20250483.9/1812A/R0/AW

Harbourside Retail - Response to Request for Additional Information

This letter has been prepared in response to the Request for Additional Information provided by the City of Sydney with respect to the retail component of the Harbourside development (D/2025/1021). The request, and a further meeting with the City of Sydney on the 3rd of December 2025, requested additional assessment with reference to Section 3.18.1 of the Sydney DCP.

Figure 1 – Ground Floor Retail Layout

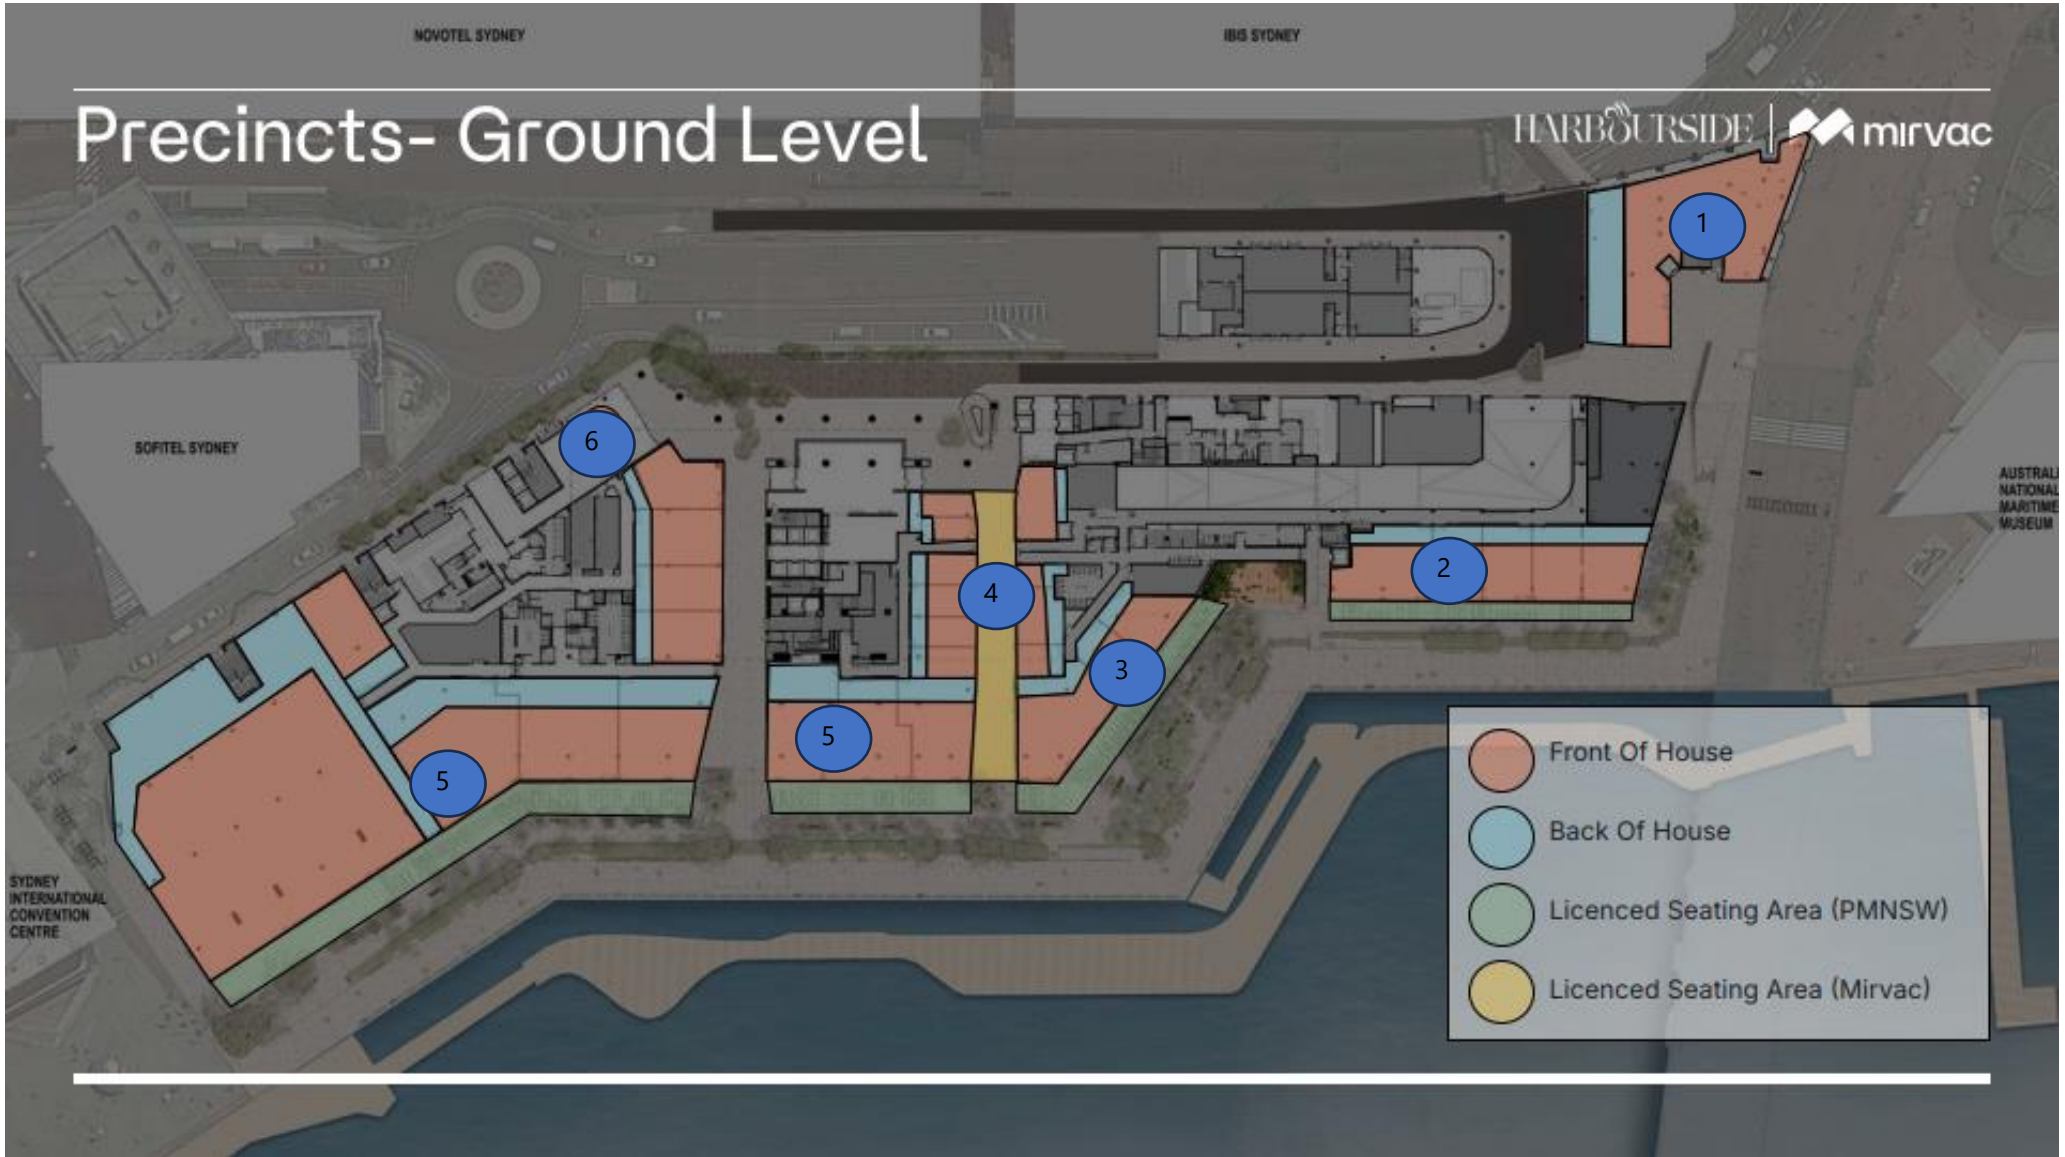
- The commentary provided by the city within the RFI presented in Section 1 of this letter requests assessment in line with the framework outlined within the City of Sydney DCP Section 3.18.

Table 4 – Modelled Operational Scenarios (Refer Figure 1)

Level	Area	Operational Area	Original Assessment	Amended Assessment	
Ground Floor	Area 1	Internal	Open Façade to 10pm	Unchanged	
		External	N/A		
	Area 2	Internal	Façade open to 12am	Unchanged	
		External	Unrestricted external dining to 12am	Unrestricted external dining to 10pm	
	Area 3	Internal	Open façade to 12am	Open façade to 10pm	
		External	Unrestricted external dining to 12am, 50% capacity dining to 3am	Unrestricted external dining to 10pm	
	Area 4 (Eat Street)	Internal	Open Façade to 12am	Unchanged	
		External	Unrestricted external dining to 12am		
	Area 5	Internal	Façade Open All Times	Unchanged	
		External	Unrestricted External Use to 3am		
	Area 6	Internal	Open Façade to 12am	Unchanged	
		External	N/A		
	Level 2	Area 1	Internal	Open façade to 10pm	Façade closed at all times
			External	Unrestricted dining to 10pm	Unchanged
Area 2		Internal	Open façade to 10pm	Façade closed at all times	
		External	Unrestricted dining to 12am	Unrestricted dining to 10pm

However, significant operational changes are required to achieve this reduction. Specifically, several outdoor dining areas are required to close at 10pm (rather than midnight), and there are further restrictions on the operation (closure) of façades.
